ENERGY NORTHWEST

September 5, 2000
GO2-00-154

Subject: **WNP-2, OPERATING LICENSE NPF-21
REQUEST FOR AMENDMENT
TECHNICAL SPECIFICATIONS 3.3.5.1, 3.3.6.1 and 3.3.6.2**

REQUEST FOR AMENDMENT

FIGURE 1
PRIMARY CONTAINMENT
INBOARD ISOLATION LOGIC
(PARTIAL)
[TYP. FOR OUTBOARD
SHOWN IN ()]
REF. FSAR
FIGURE 7.3-8.1

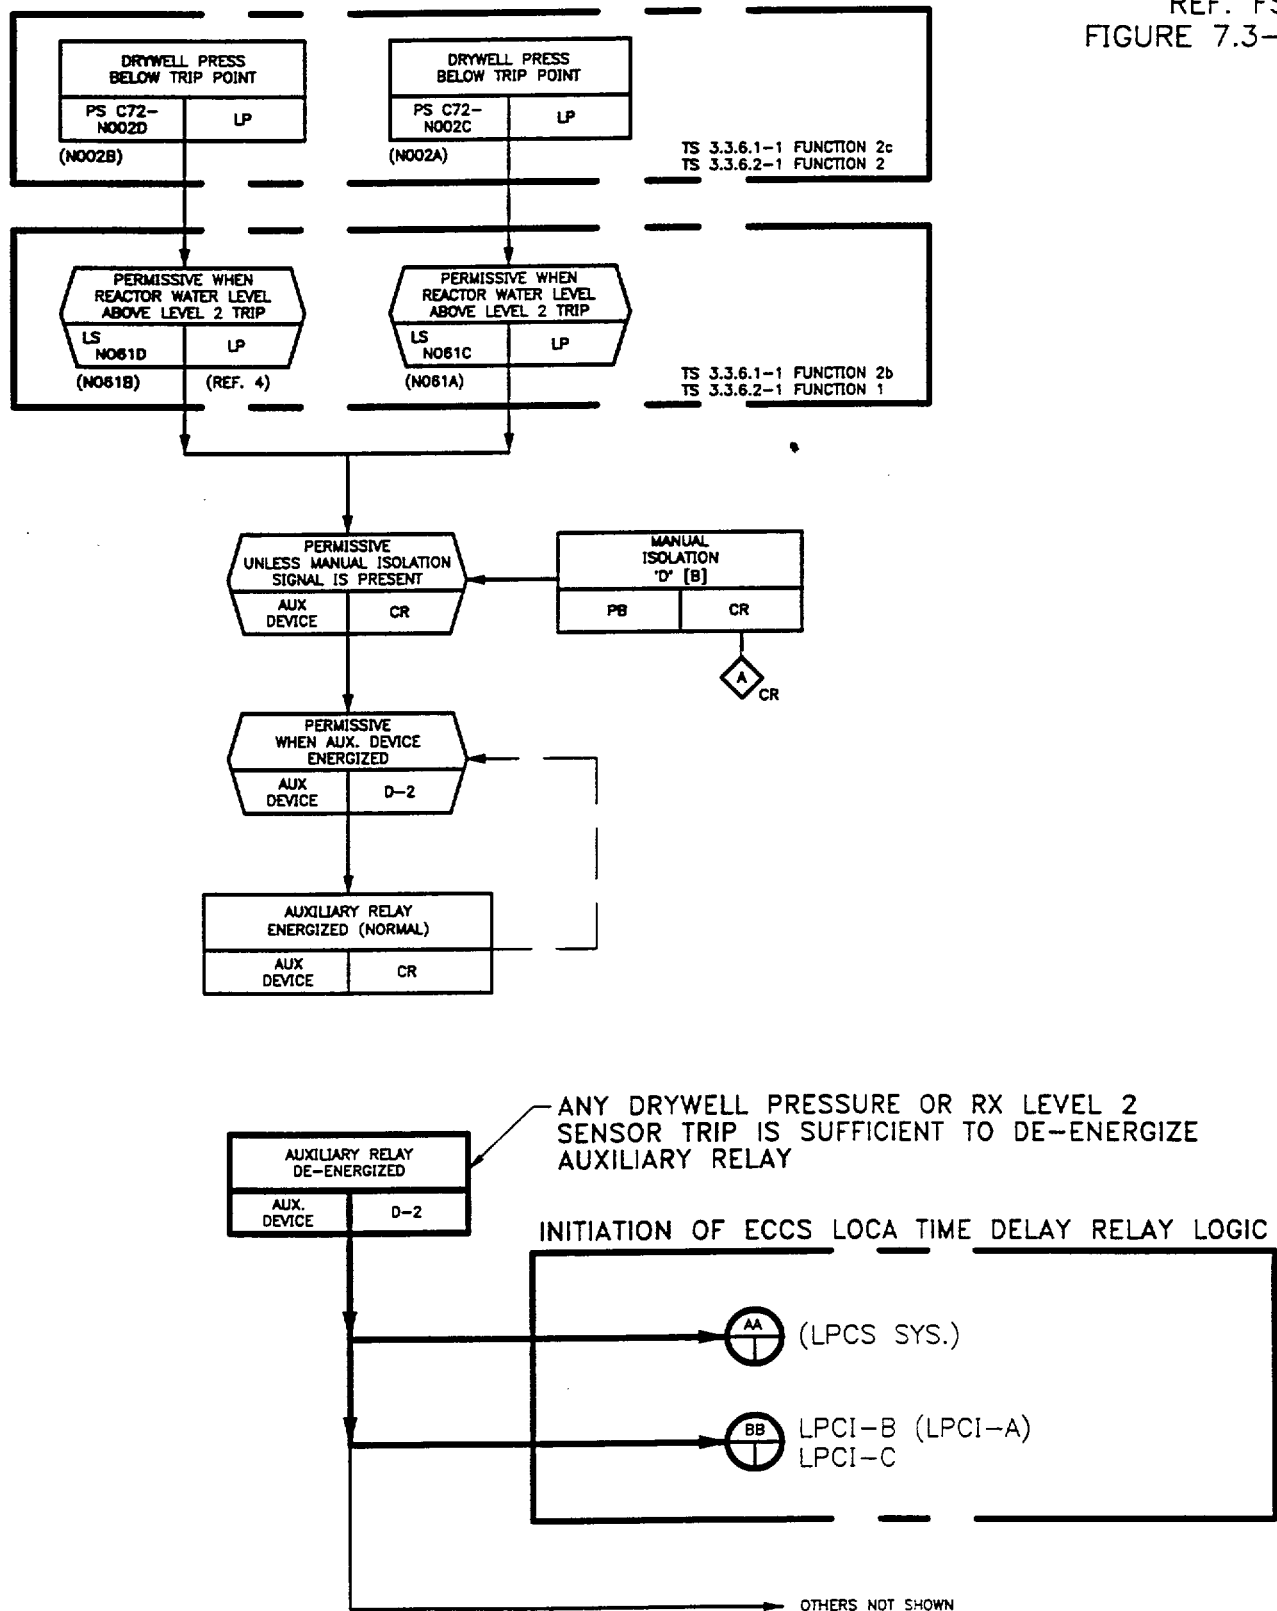
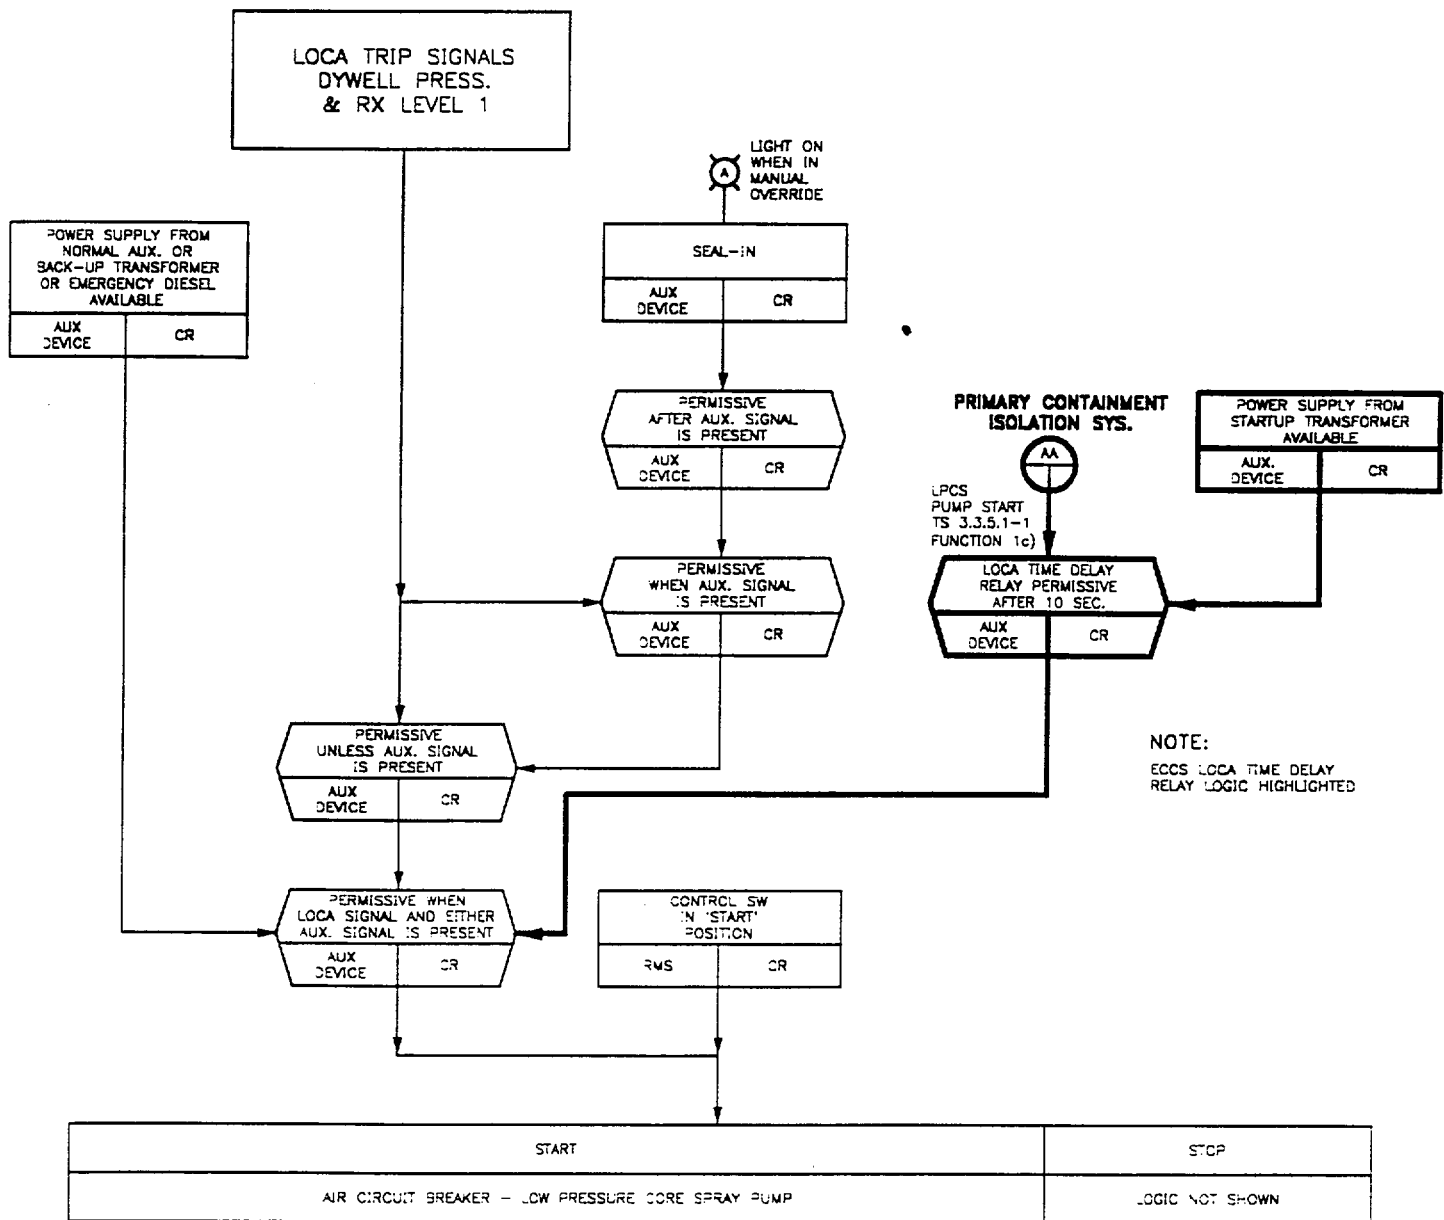
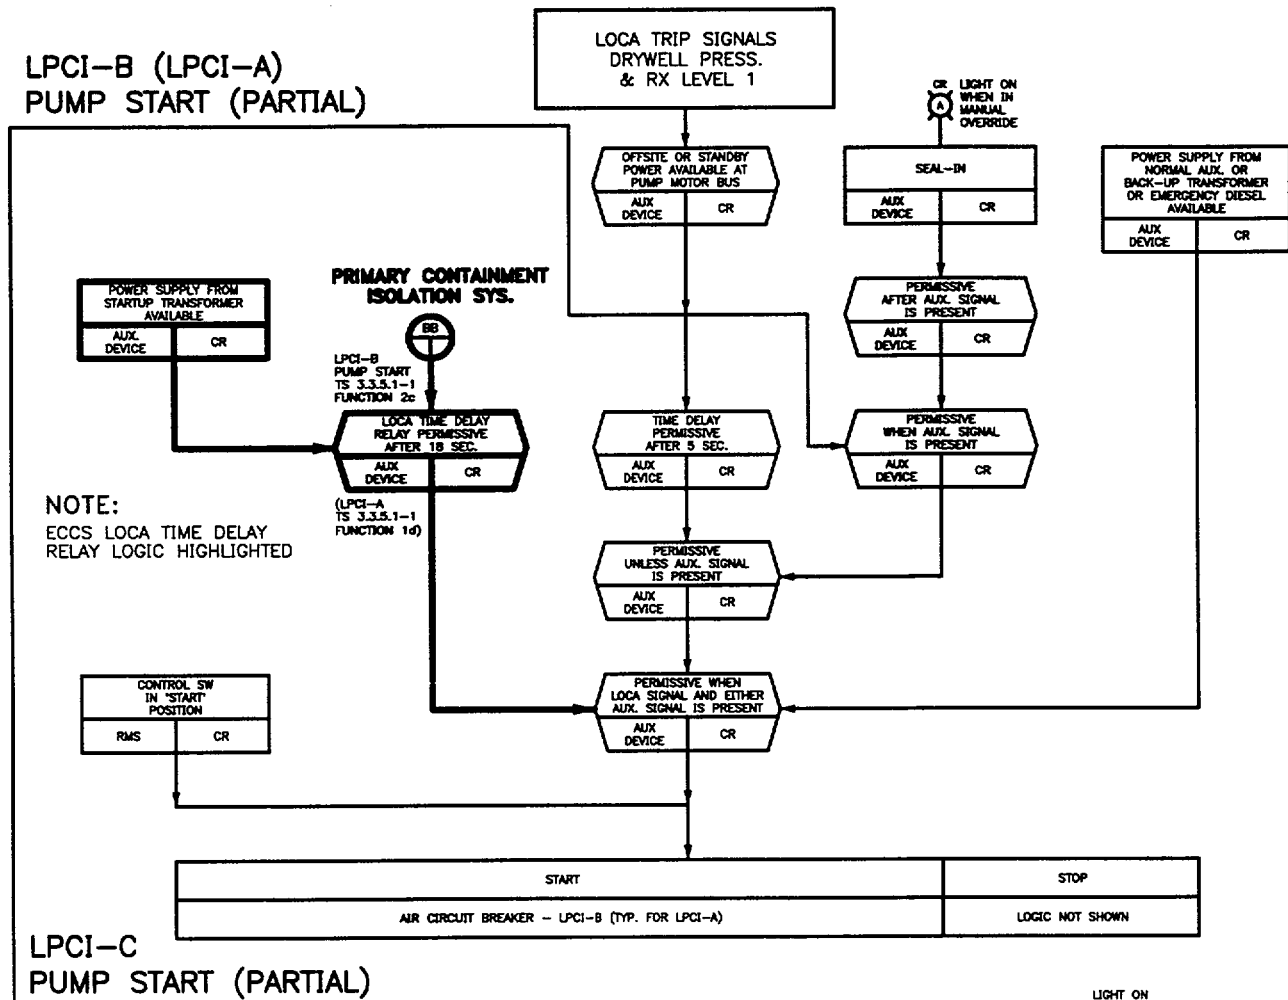
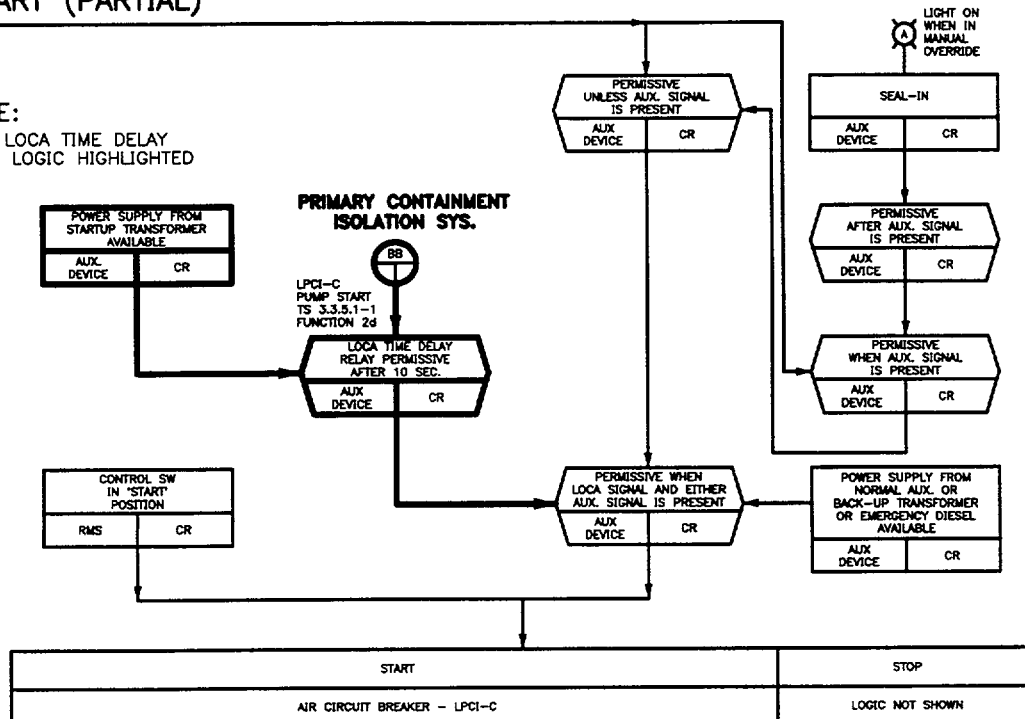
Pump-start TDR channels are included in each of the Division 1 and 2 low pressure ECCS pump-start logic trains. Each of the four low pressure ECCS pump-start designs contain a TDR relay channel initiated by a Drywell Pressure-High or a Reactor Vessel Water-Low Low, Level-2 sensor contact in series, together with other logic associated with electrical system relay and circuit breaker position. The WNP-2 design is such that actuation of any one of the sensors results in providing an actuation signal to the TDR channels for both low-pressure ECCS pumps in the same electrical division (See Figures 1-3).

In the event that one of the sensors was spuriously actuated, or was placed in the trip condition as required by any of the affected Technical Specifications (in the case of an inoperable instrument), both LOCA TDR channels in the division would receive an actuation signal. When power is aligned to the 230 kV offsite power source, the time delay relays will start and time-out, setting up the logic for simultaneous starts upon receipt of a LOCA signal (See Figures 1-3). Since the actual start of the low pressure pumps is dependent on LOCA signals that originate in other branches of the WNP-2 instrumentation systems (See Figures 2-3),

The primary and secondary containment isolation channels specified in Table 3.3.6.1-1 (Functions 2b and 2c) and in Table 3.3.6.2-1 (Functions 1 and 2) initiate the LOCA TDR specified in Table 3.3.5.1-1 (Functions 1c, 1d, 2c, and 2d). Since these Drywell Pressure and Reactor Level 2 signals are used in several functions governed by multiple Technical Specifications, we are proposing to add notes to these Technical Specifications to identify the branching to the other requirements. The note to the, "Required Channels Per Trip System," column for Table 3.3.6.1-1 Functions 2c and 2d is, "(e) Also required to initiate the associated LOCA Time Delay Relay Function pursuant to LCO 3.3.5.1." The note for 3.3.6.2-1 Functions 1 and 2 is identical, except it is labeled as Note (c). These notes will direct the operators to LCO 3.3.5.1 and a more restrictive Action.
